RFQ NUMBER
 DEFK7044

ADDENDUM #01

ADDENDUM # 1

PROJECT: KINGWOOD READINESS CENTER
Camp Dawson
Kingwood, West Virginia

SHEET NUMBER: SD-A-004

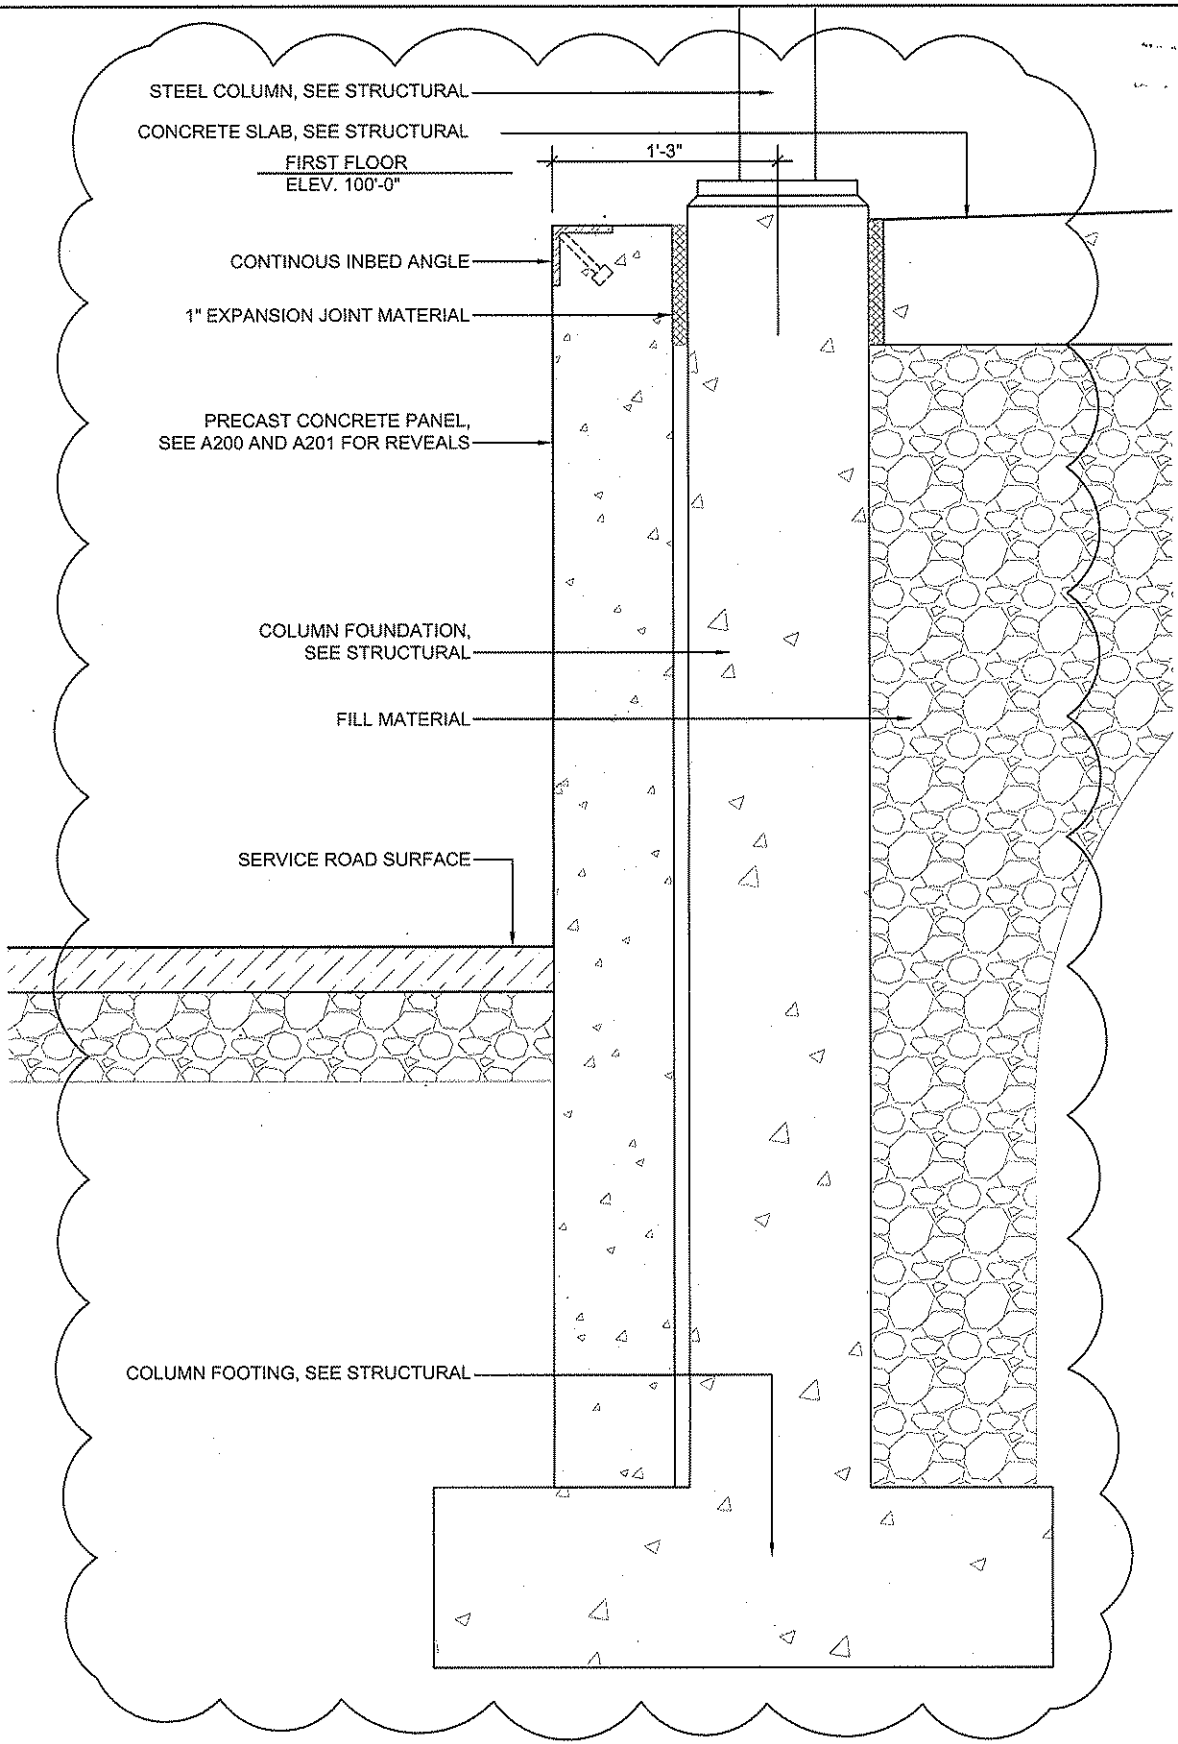
- 01-0024: Delete 1/A315 WALL SECTION and replace with revised wall section drawing per architectural supplemental drawing SD-A-003 attached.
- 01-0025: Delete 4/A512 SECTION DETAIL and replace with revised detail 1/A512 SECTION DETAIL AT DOCK CANOPY per architectural supplemental drawing SD-A-004 attached.

SHEET NUMBER: SDA-005	REVISION DATE: 08/07/06	DESIGNED BY: H. MOUSAVI	DESIGNED BY: K. SPOODEN
		CHECKED BY: D.C.D.	CHECKED BY: D.C.D.

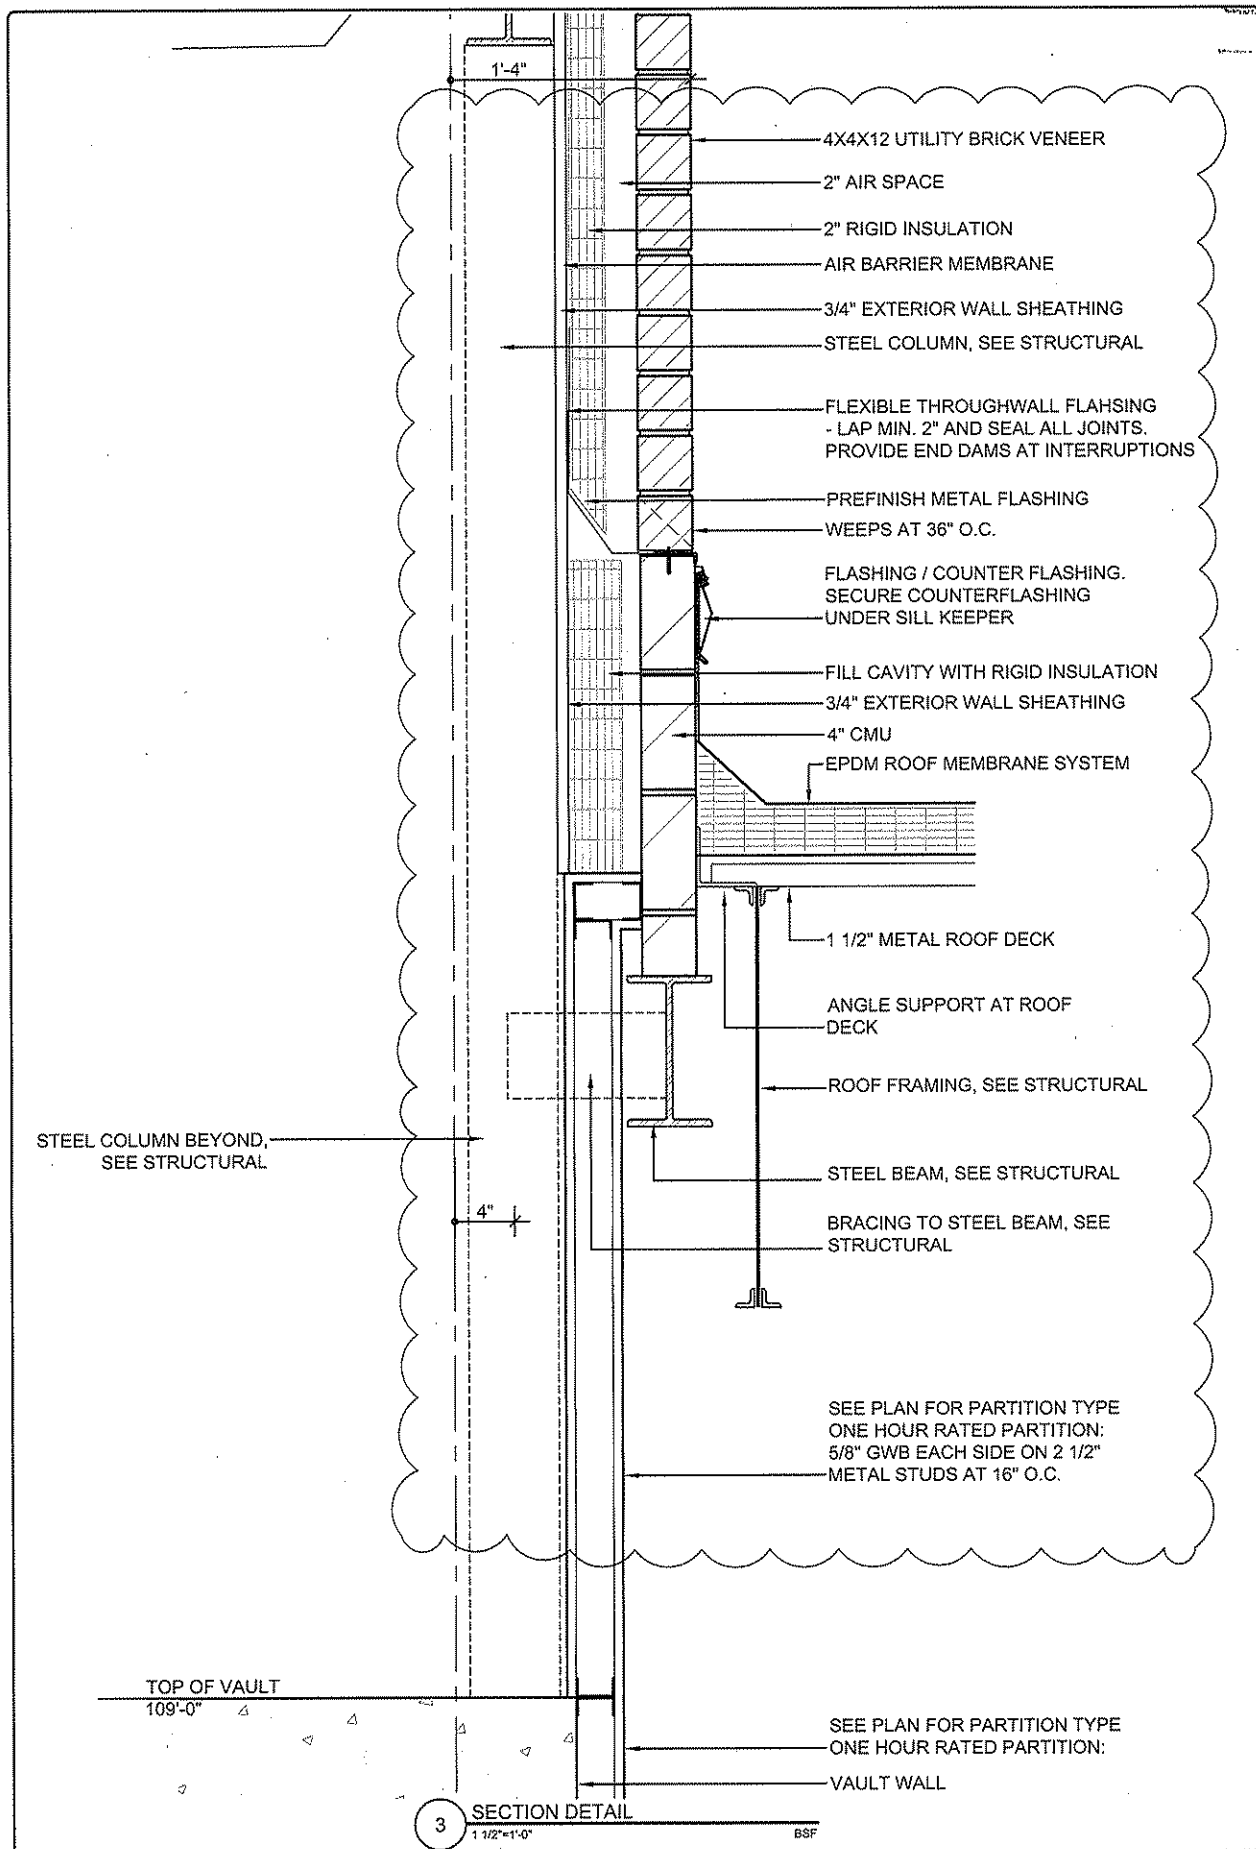
- 01-0026: Delete 7/A512 SECTION DETAIL and replace with revised detail 7/A512 SECTION DETAIL AT LOADING DOCK per architectural supplemental drawing SD-A-005, attached.

DESIGNED BY: H. NOUGHANI	DRAWN BY: K. SPODEN	CHECKED BY: DCD	REVISION DATE: 08/07/06	SHEET NUMBER: SD-A-008
-----------------------------	------------------------	--------------------	----------------------------	---------------------------

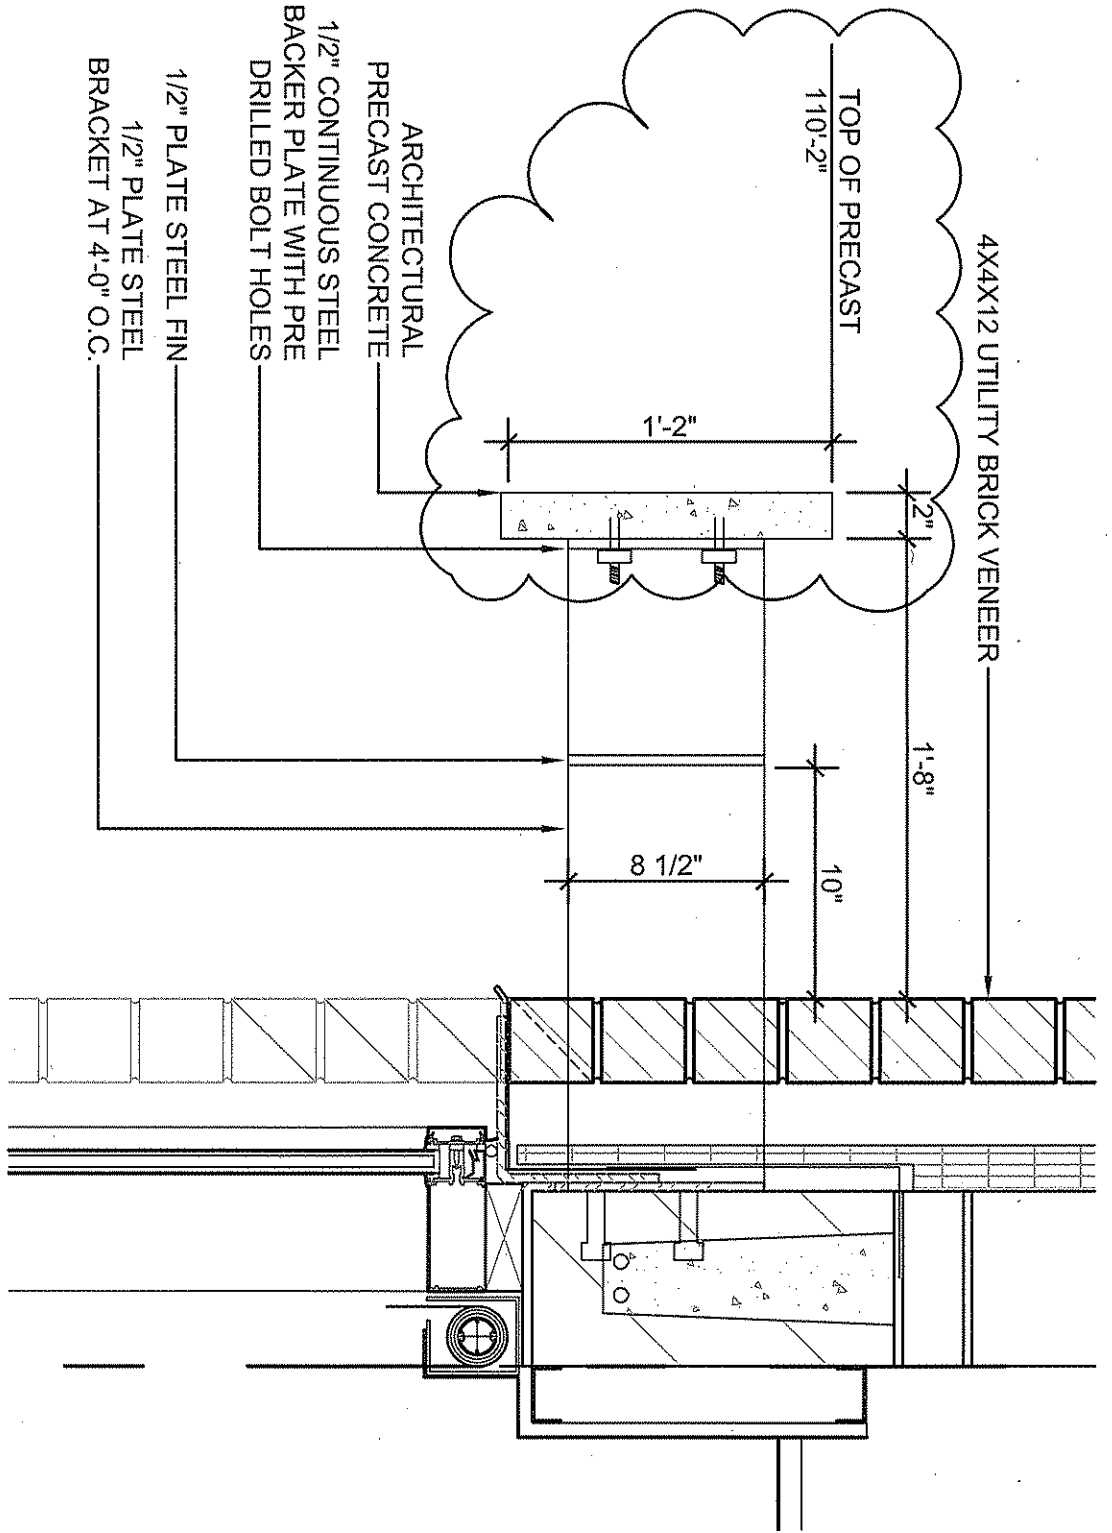
- 01-0031: Delete 4/A514 SECTION DETAIL AT SOLAR SHADING and replace with revised drawing per architectural supplemental drawing SD-A-008, attached.
- 01-0032: Add detail 8/A514 CANOPY PLAN DETAIL AT CORNER per architectural supplemental drawing SD-A-009, attached.

DESIGNED BY: H. MOUSHARI	DRAWN BY: K. SPEDEN	CHECKED BY: DDO	REVISION DATE: 08/07/06
SHEET NUMBER: SD-A-010

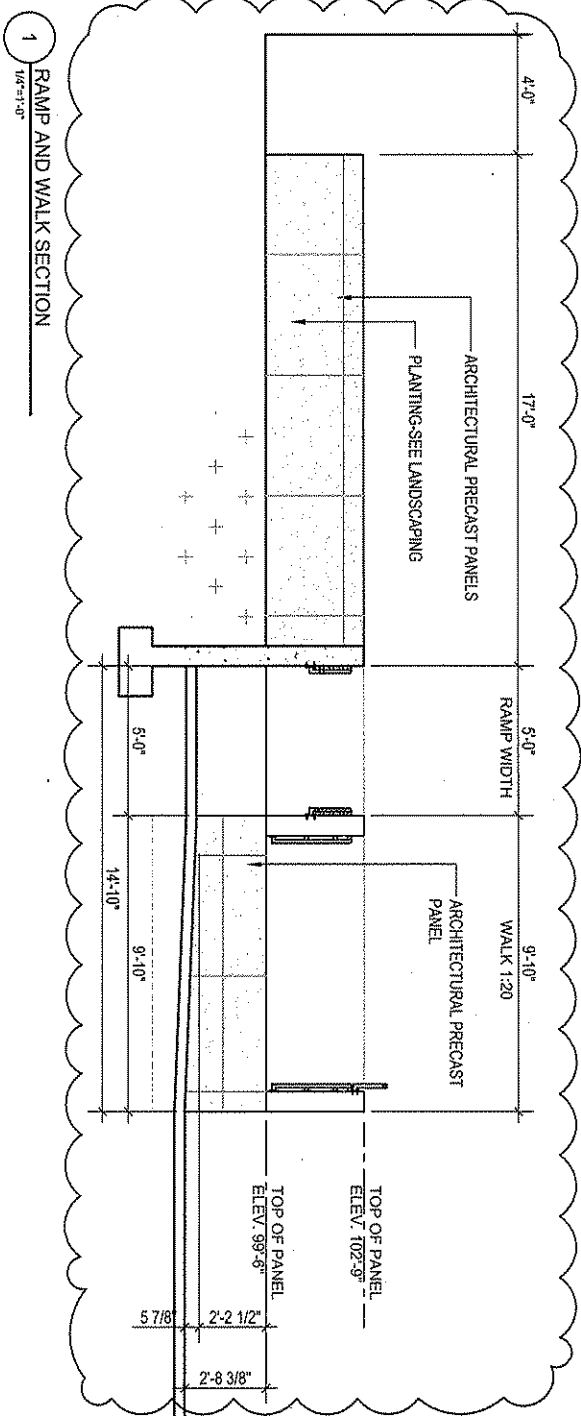
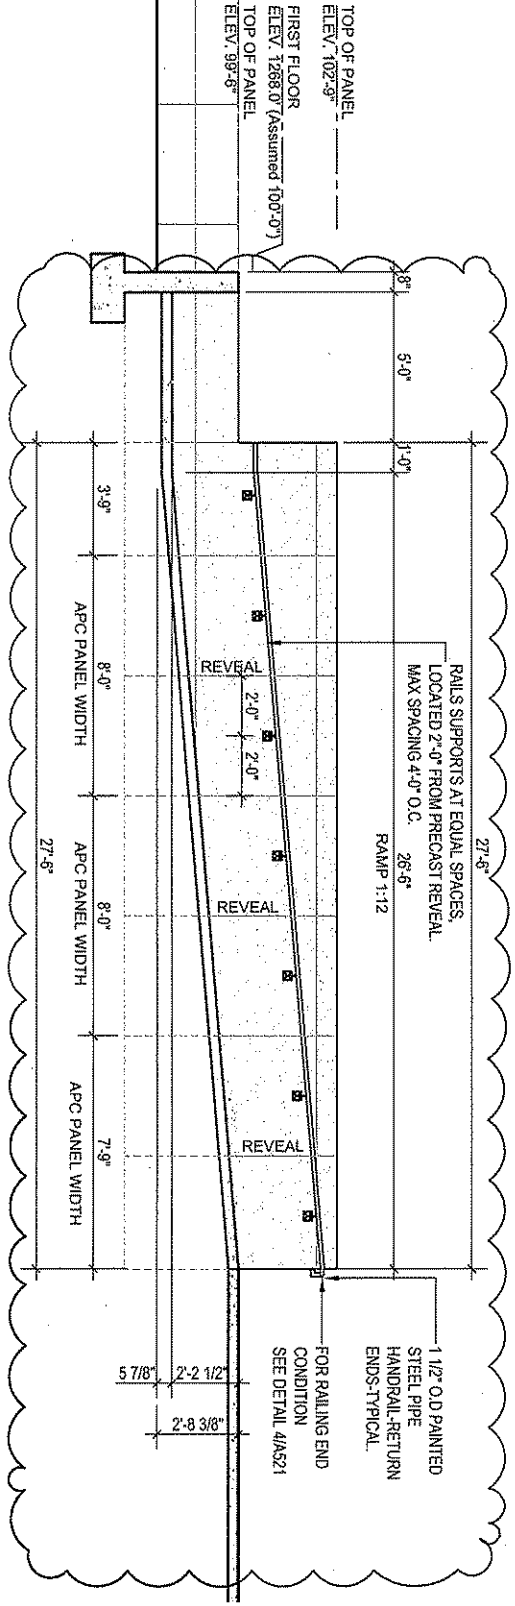
- 01-0033: Delete 1/A519 RAMP SECTION AND 2/A519 RAMP SECTION and replace with revised drawing per architectural supplemental drawing SD-A-010, attached.

DESIGNED BY: H. KOUSSHANI
 DRAWN BY: K. SPODEN
 ORDERED BY: DCD
 REVISION DATE: 08/07/06
 SHEET NUMBER: SD-A-011

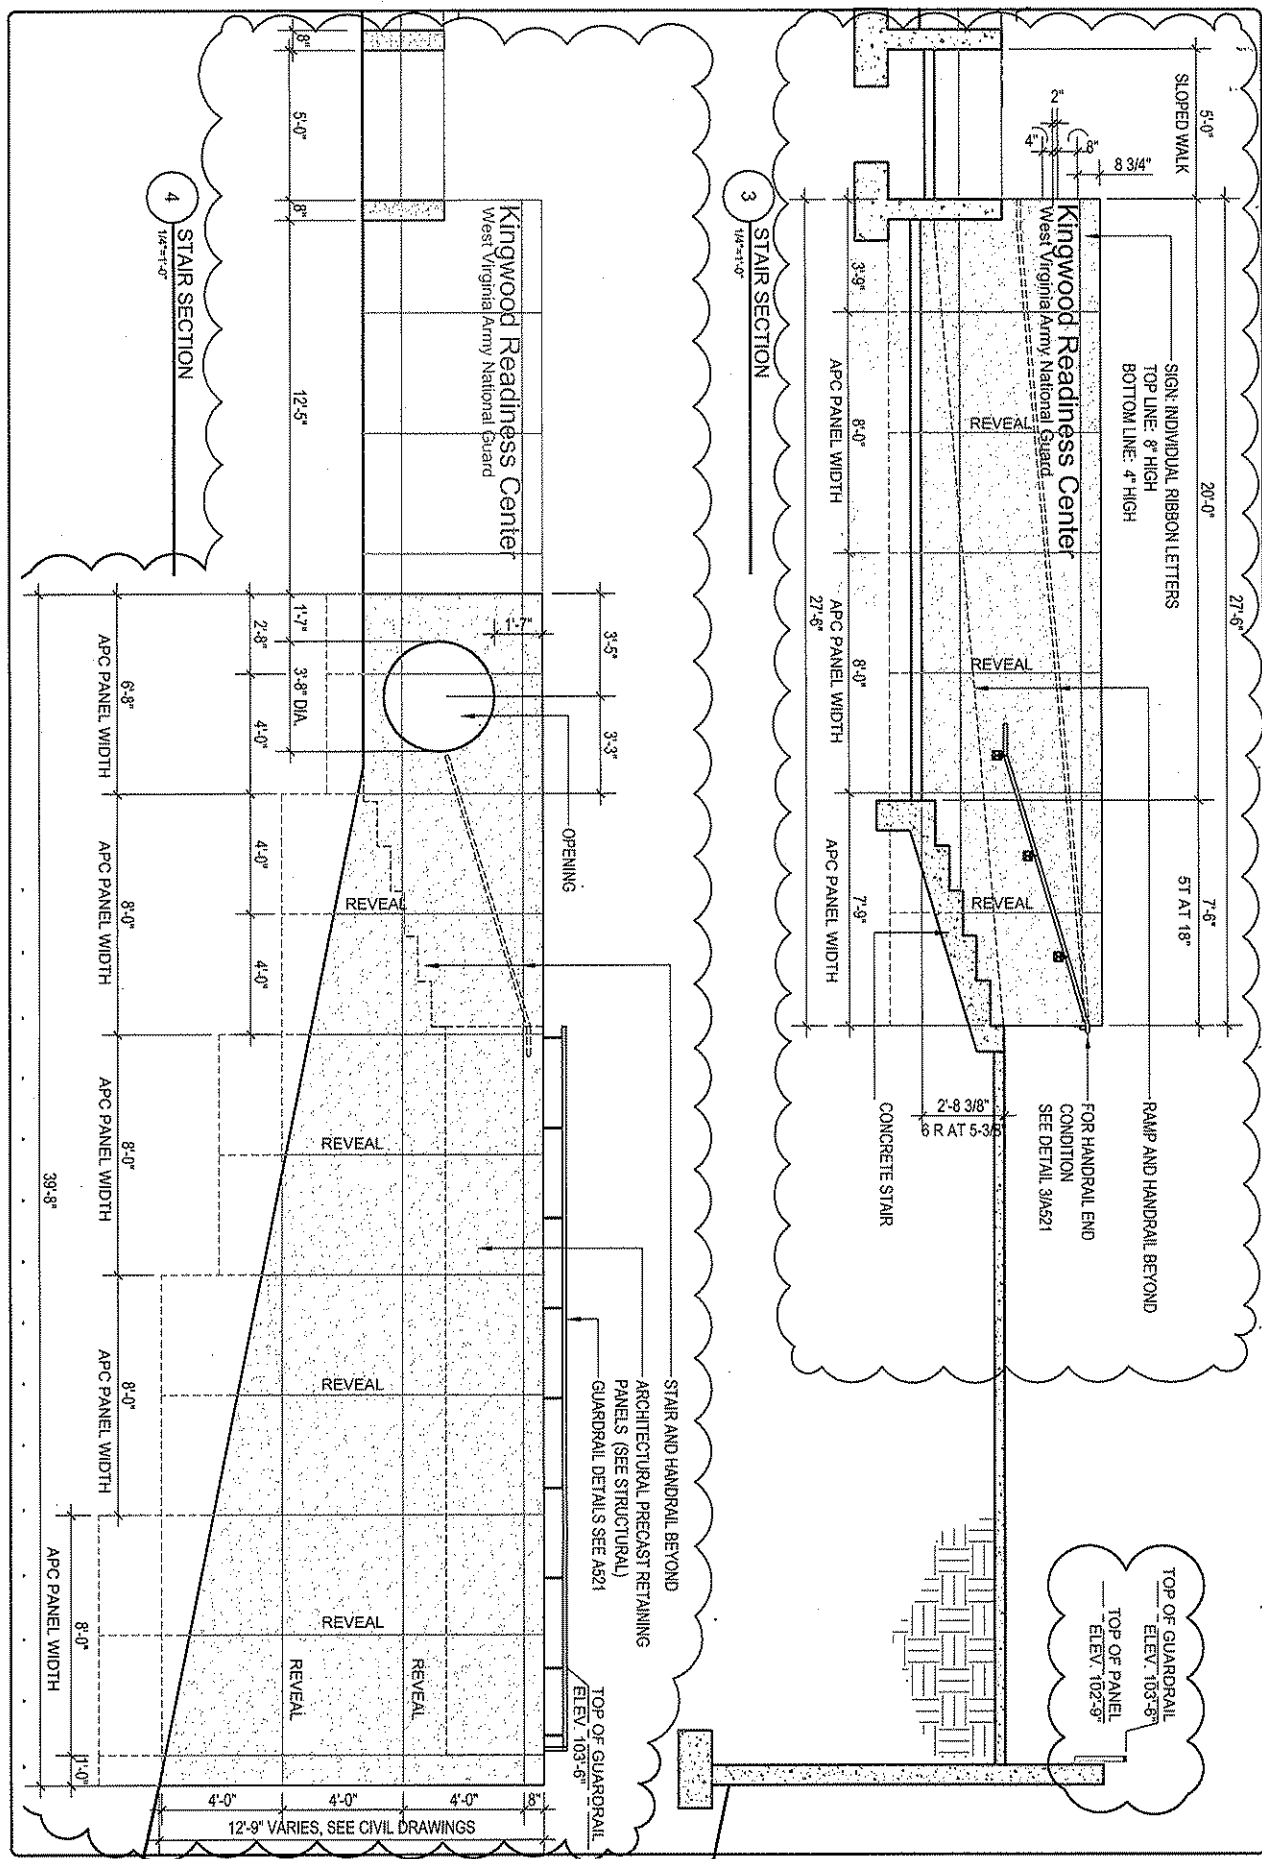
- 01-0034: Delete 3/A519 STAIR SECTION AND 4/A519 STAIR SECTION and replace with revised drawing per architectural supplemental drawing SD-A-011, attached.
